To: Shauna Redican
Cc: King, Kevin
Subject: RE: CBL Delay Request - Gentry B14 (045-15589)

Pad: Gentry B
Well: Gentry B14
API No.: 05-045-15589-00
Permit No.: 400237526

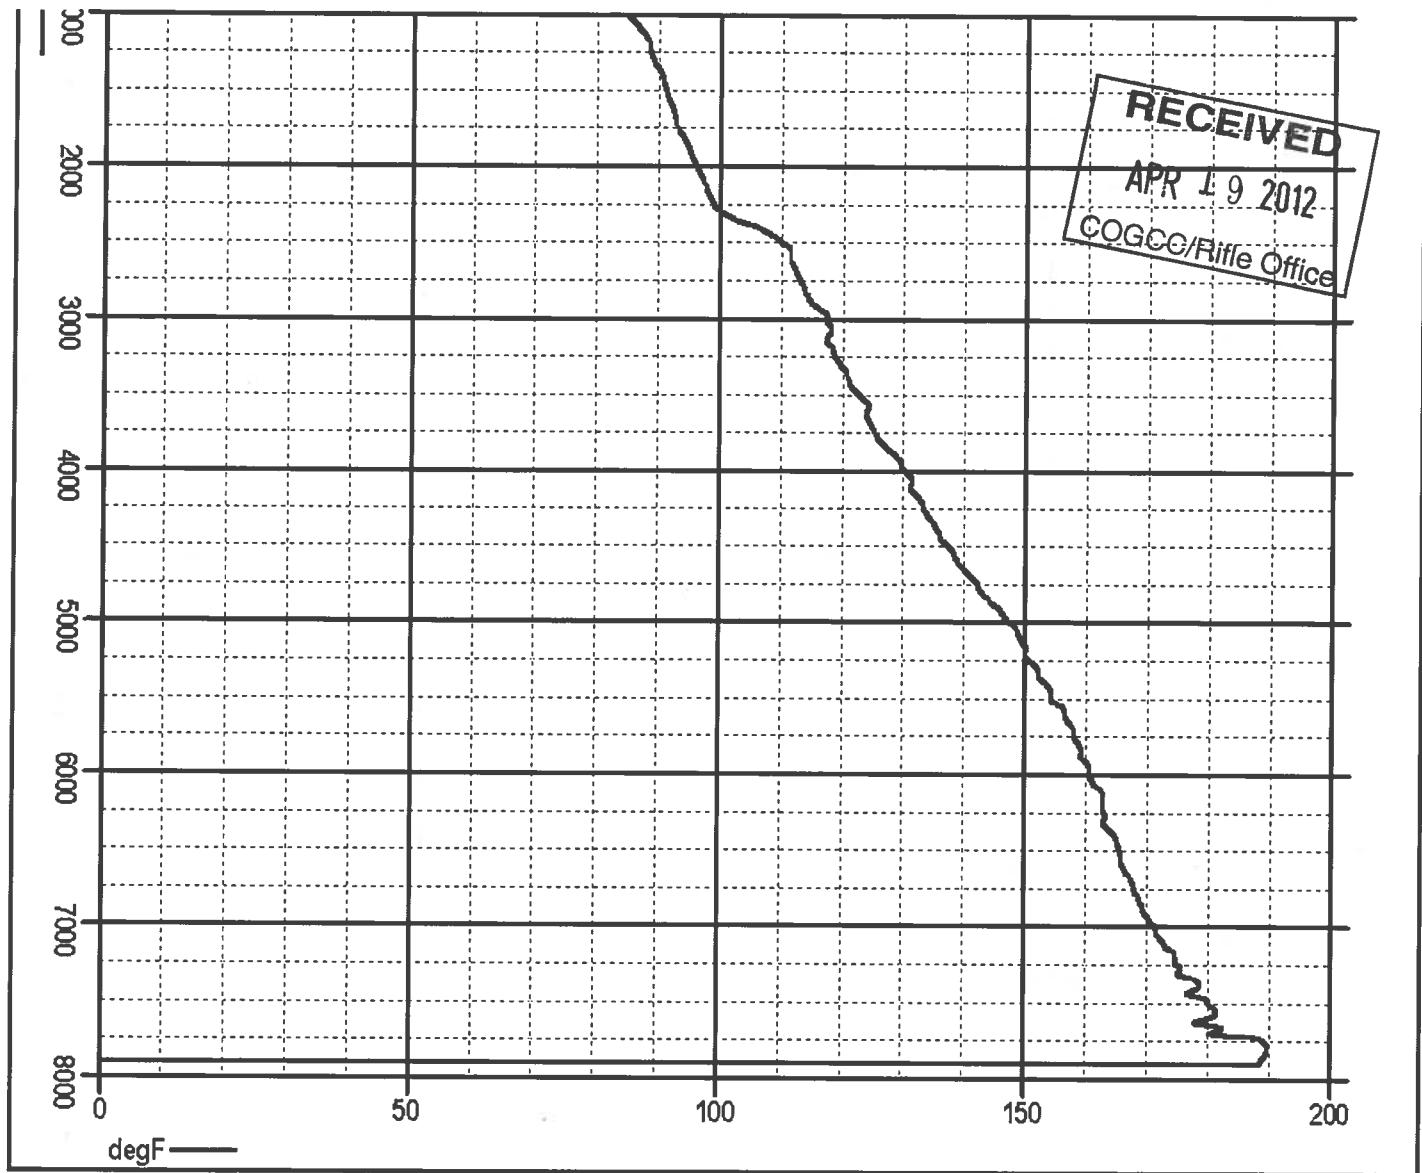
Kevin is back in from the field and should soon be able to review the work which he had done before. And so ...
Mr. King: is the information which Shauna has provided in her email, below, sufficient for the CBL deferment determination (*) or would you rather see a more-filled-out bradenhead-pressure "table" with the amount of fluid needed to fill the well also included?

*The temp log does support the TOC of 2450'.

Antero Resources Piceance Corporation is requesting a CBL deferment on the Gentry B14 described below. A temperature survey was run following cementing the 4-1/2" production casing on the subject well and is attached.

Antero can delay running the CBL on the subject well.
